FIELD SERVICE BULLETIN

NO. 31
MAY 9, 1947

SUBJECT: ENGINE MOUNT FRONT FRAME REINFORCEMENT

Figure 1. - Engine Mount Reinforcement

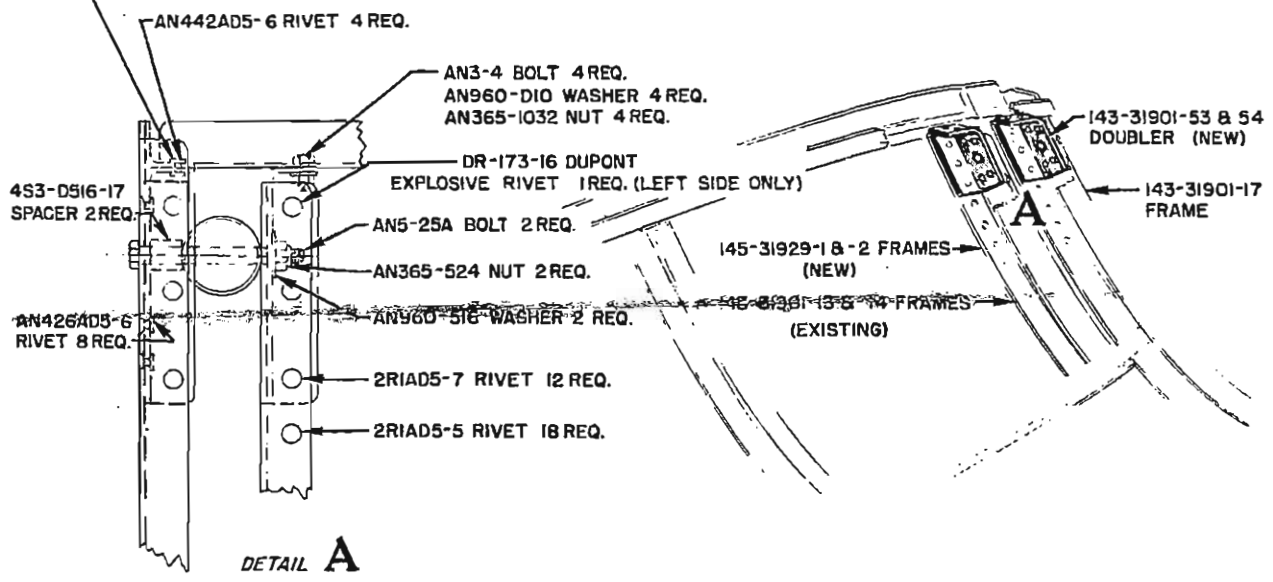
The front engine mount frames 143-31901-13, -14, and -17, have been found to develop fatigue cracks near the longeron. The required parts to reinforce these frames are contained in Kit 145-89035.

8. Clamp 143-31901-53 and -54 doublers to the aft side of 143-31901-17 frame aligning the flanges of the doubler against the frame flange and longeron.
9. Drill through the 143-31901-17 frame (on the vertical face) and longeron with a No. 21 (.159) drill. Install rivets

and drive. (AN3 bolts may be used as a substitute for the rivets on the longeron).

10. Drill the 5/16 inch bolt hole through the installed doubler.
11. Draw a center line on the outboard flange of the new 145-31929-1 and -2 frames.
12. Position the front engine mount tubular support before installing 145-31929-1 and -2 frames.
13. Clamp the new 145-31929-1 and -2 frames to the longeron and 143-31901-5 and -6 channels, with the flange center line on the existing skin rivet holes.
14. Drill No. 21 (.159) holes through skin rivet holes and 143-31901-13 and -14 frame flanges, being careful not to elongate skin rivet holes.
15. Drill No. 12 (.189) holes through the upper and lower flanges of the 145-31929-1 and -2 frames. Install AN3-4 bolts, AN960-10 washers, and AN365-1032 nuts.

NOTE: At first rivet hole below longeron frame 145-31929-1 install DR-143A-16 Du Pont explosive rivet. If the existing doubler spot welded to the top side of the longeron interferes with the installation of the AN3 bolt, trim a washer and install under the bolt head.

16. Secure the front tubular engine mount cross-rod using two AN5-25A bolts, two 483-D516-17 spacers, two AN960-516 washers and two AN365-524 nuts. Place the spacers between the front frame and the tubular cross-rod.
17. Compliance with this Bulletin must be entered in the airplane log book.

NOTE: Torque the engine load mount bolts to 450-500 inch pounds.
